## MEMORANDUM ADDENDUM #2

**TO:** All Bidders  
**FROM:** David Chen  
**DATE:** April 7, 2021  
**RE:** Reconstruction to the Dobbs Ferry Springhurst Elementary School and Middle/High

## **ADDENDUM NO. 2 dated April 7, 2021**

BID Addendum No. 2  
to  
Drawings and Project Manual

**BM03B**

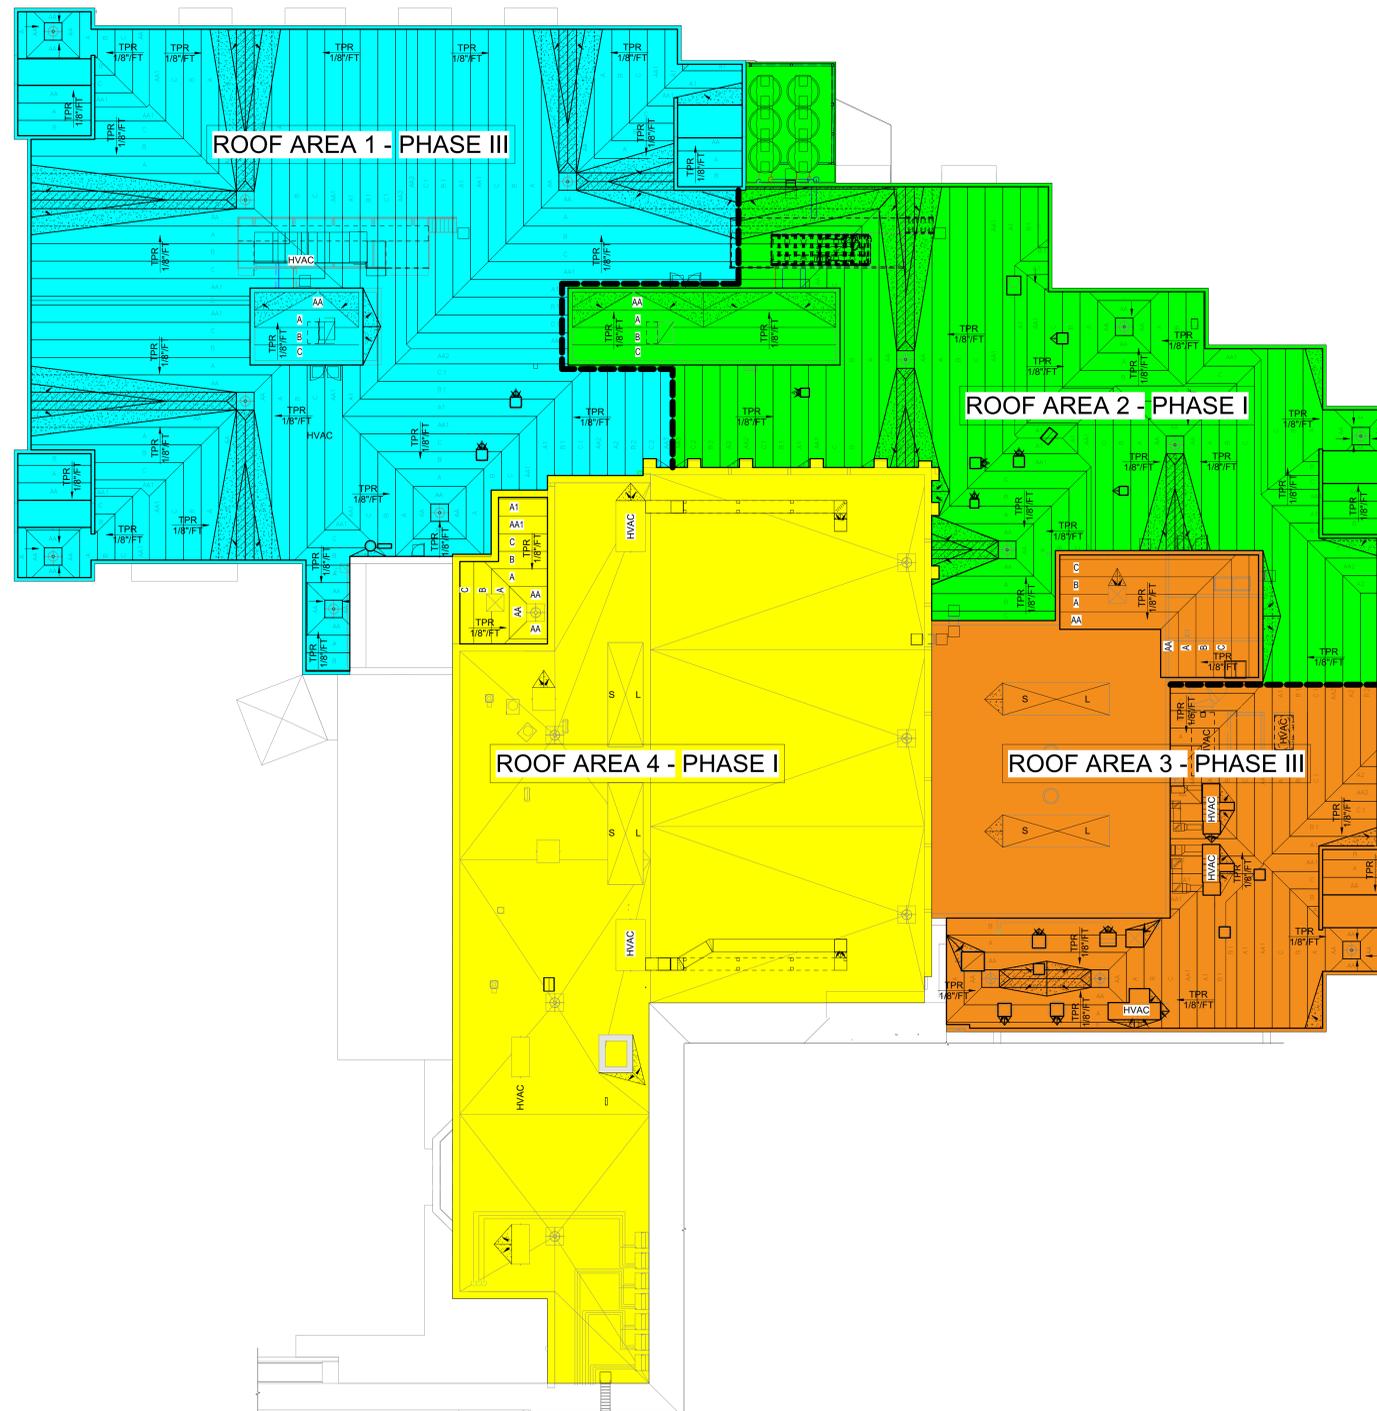
ITEM 2-C-15: Refer to DRAWING BM701

1. Detail 5, DELETE in its entirety and, ADD Drawing BM03B attached to this addendum.
